**BLUE BLAZE COAL CO.
P.O. Box 784
Price, Utah 84501
Ph. 801-472-3786**

Response to Comment 724.100 Baseline Information: Groundwater

Ms. Pamela Grubaugh-Littig
March 26, 1992
Page 14

FIGURE 2. POTENTIAL RECHARGE AREAS

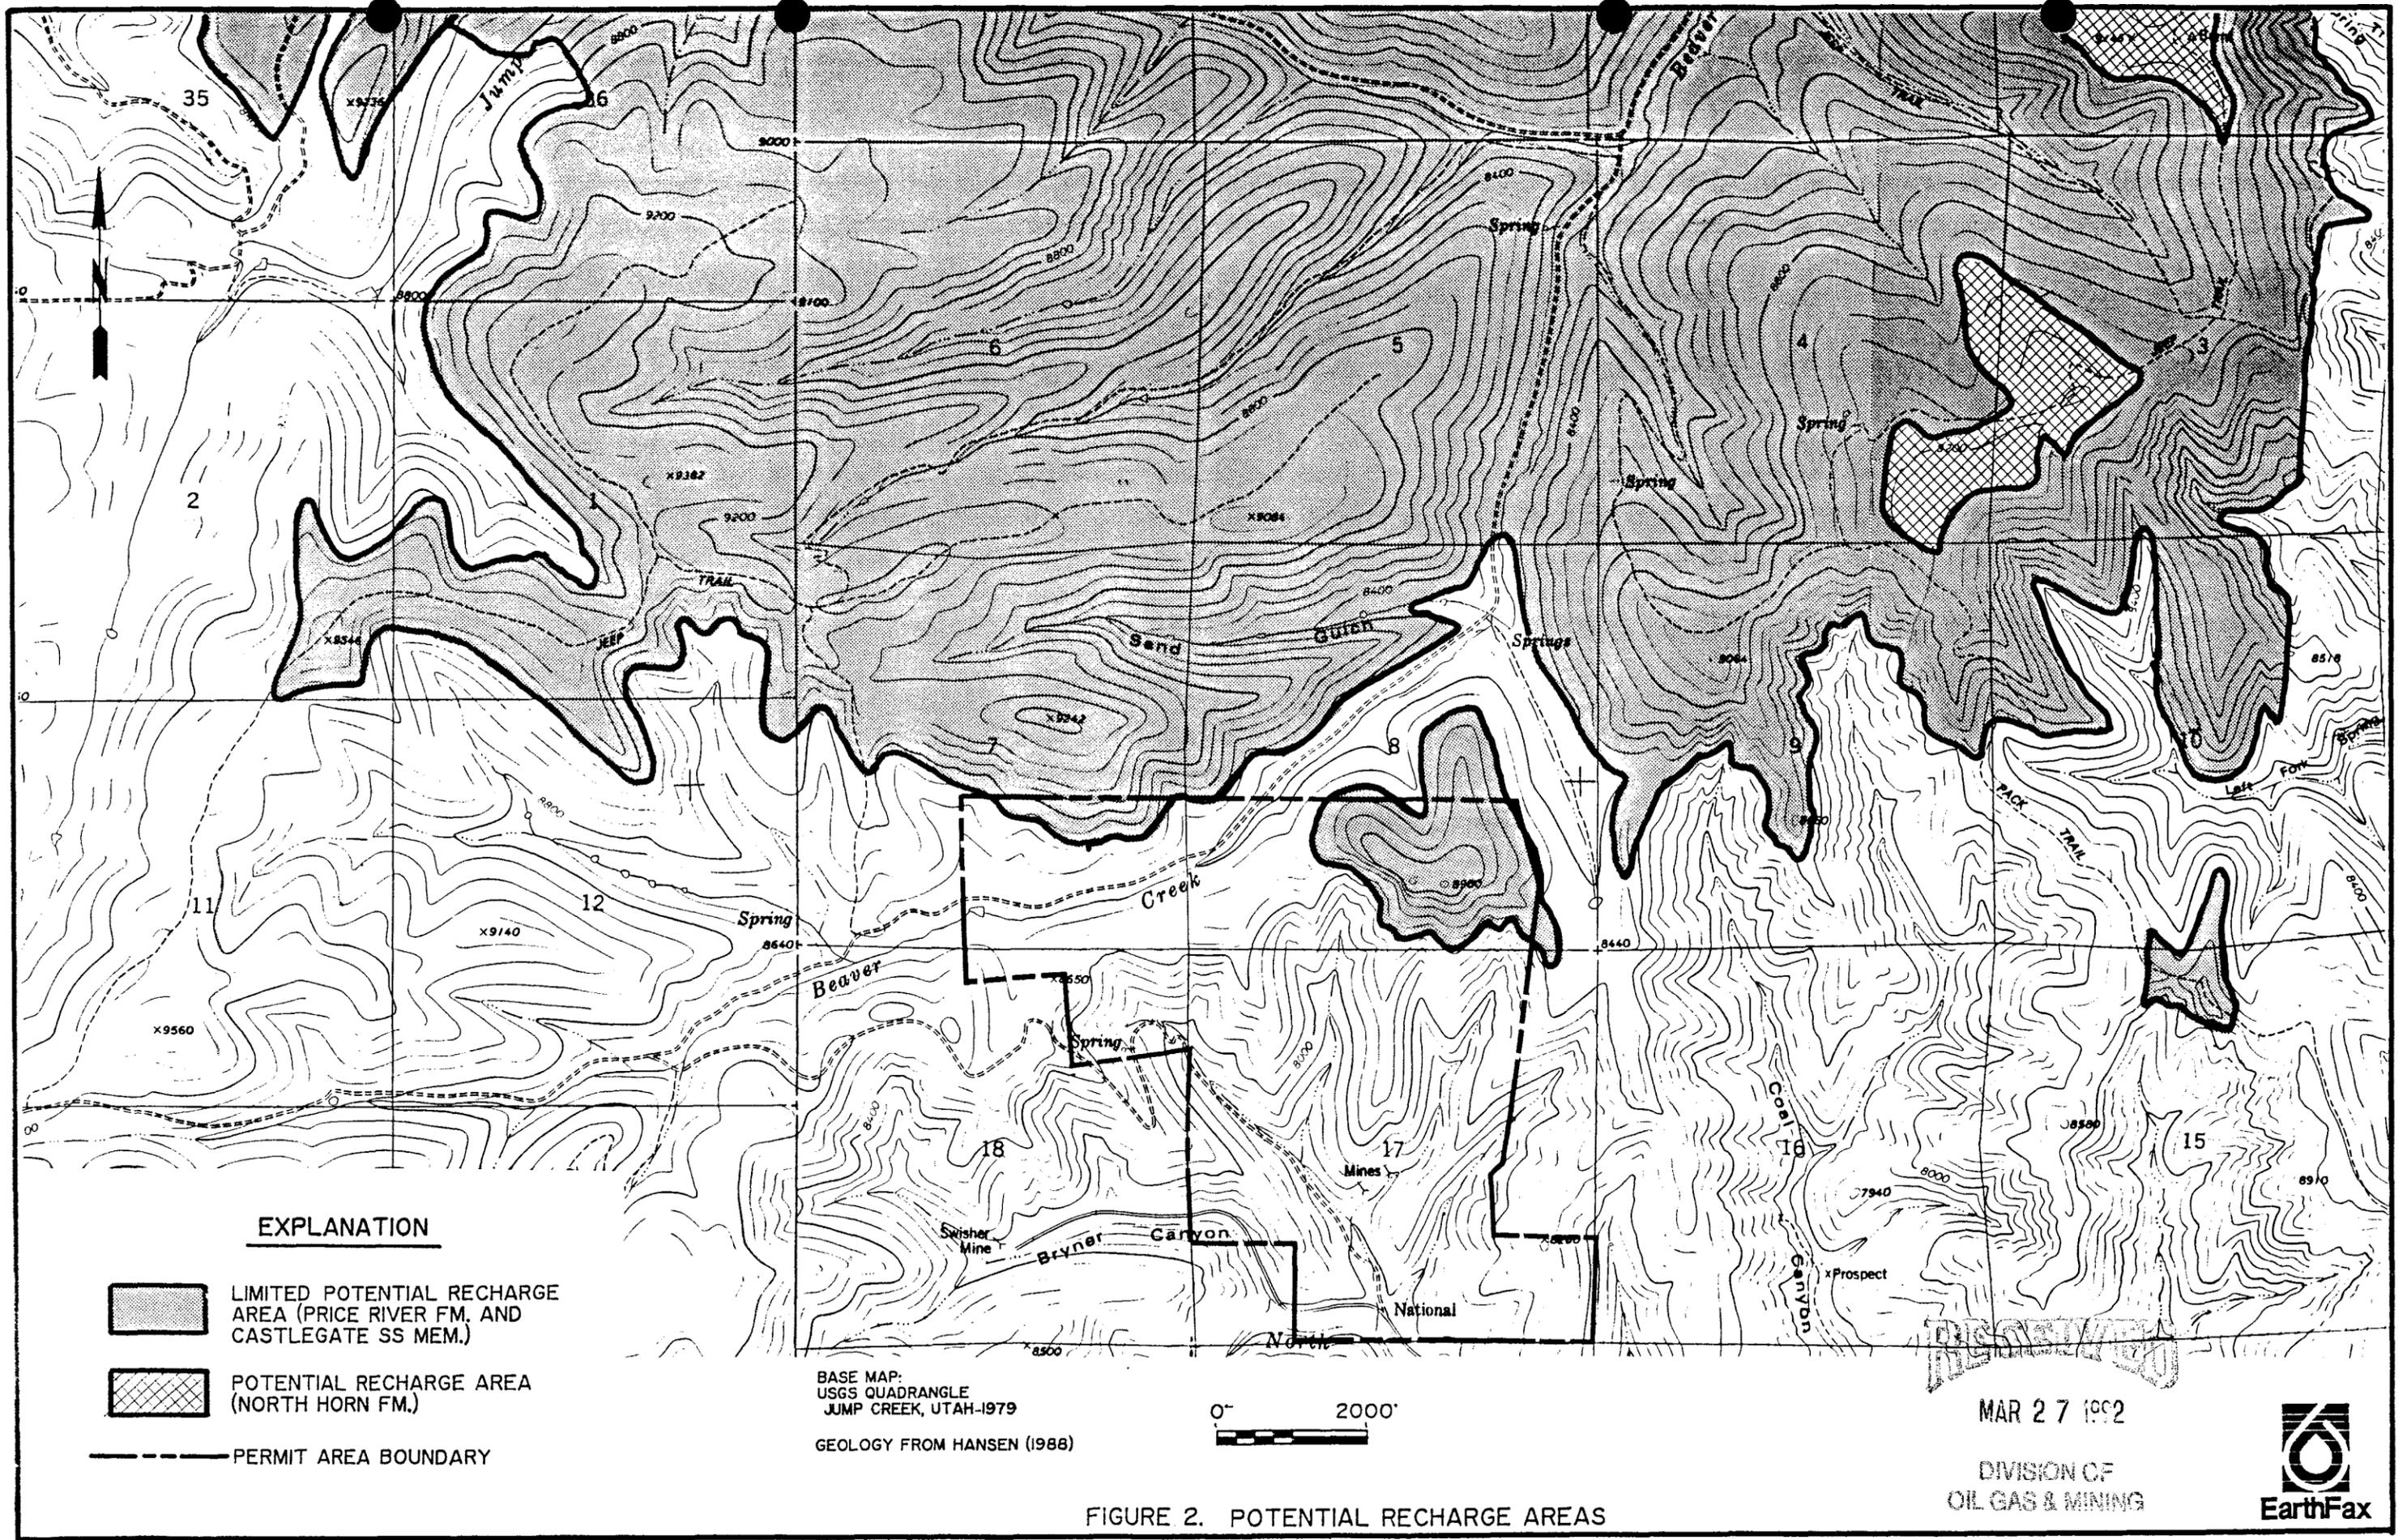
Response to Comment 724.500 Supplemental Information

As noted by the Division, a discussion of recharge potential within the permit and adjacent areas was provided on pages 9 and 10 of the March 11 submittal. Figure 2 is presented herewith to supplement that information.

Figure 2 shows the locations of outcrops of formations above the Blackhawk Formation. Areas where the Price River Formation outcrops are identified as having a limited potential for recharge. This designation is based on the discussions on pages 2, 3, and 10 of the March 11 submittal. Note particularly the discussion on page 10 of the March 11 submittal which states that "in areas that are capped by the Price River Formation and the Blackhawk Formation (such as occur within the proposed permit and adjacent areas), Danielson et al. (1981) indicated that 'steep slopes promote rapid snowmelt runoff and **reduce recharge to the groundwater system**'. This condition is intensified by the relatively low permeability of the Price River and Blackhawk Formations. The limited amount of recharge in the area is reflected by the small number of springs as well as the dry conditions encountered by previous mine workings in the permit and adjacent areas and the LMC drill holes" (italics and bolding added).

Areas on Figure 2 identified as having a potential for recharge are overlain by the North Horn Formation. Of the total area covered by formations above the Blackhawk Formation on Figure 2, only 3 percent of the area is overlain by the North Horn Formation where the potential for recharge is considered to be greater than "limited". It should be noted that no areas south of the proposed permit area and within the same 7.5 minute Jump Creek Quadrangle are overlain by formations above the Blackhawk Formation.
